3
4 AN ORDINANCE approving and ratifying
5 contracts for the construction of the
6 Botanical Conservatory.

The Project: PLANT CONSERVATORY
Fort Wayne, Indiana

The Architect: ARCHONICS
4009 East State Boulevard
Fort Wayne, Indiana 46815

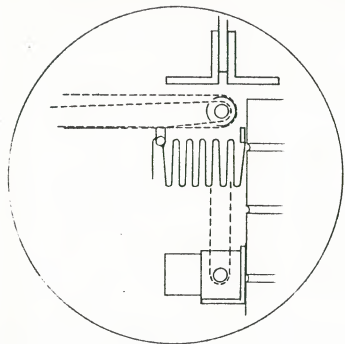
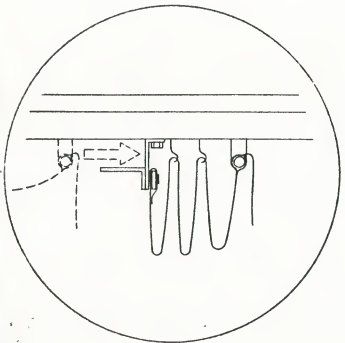
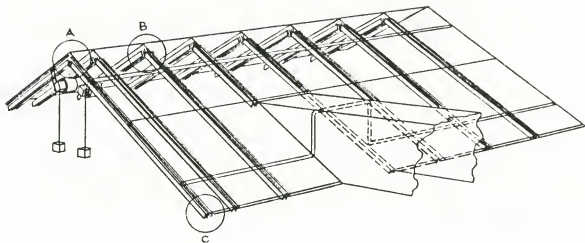
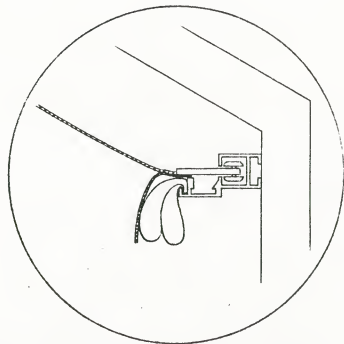
Electrical Service System - Wiring of Equipment Furnished by ROLL-OUT, Inc.: Provide required electrical connections for equipment furnished and installed by ROLL-OUT, Inc. Information herein is for estimating purposes; wiring shall be as necessary to provide proper operation of equipment. Provide 110 V 20 Amp. service to each of two drive units mounted on gable end wall in each of three greenhouses. Provide 110 V 1.5 Amp. service from one drive unit on the wall to blower in ridge of greenhouse at the gable end of each of three greenhouses.

Provide 10-110 V 3 Amp. control lines from each of six control panels to each of six drive units. Install one infra-red receiver/transmitter on roof at the gable end of each of three greenhouses. Provide 110 V 4 Amp. service and two 110 V 3 Amp. control lines from each of three receivers to each of six control panels. Provide material and labor to install six control panels three infra-red transmitters/receivers.
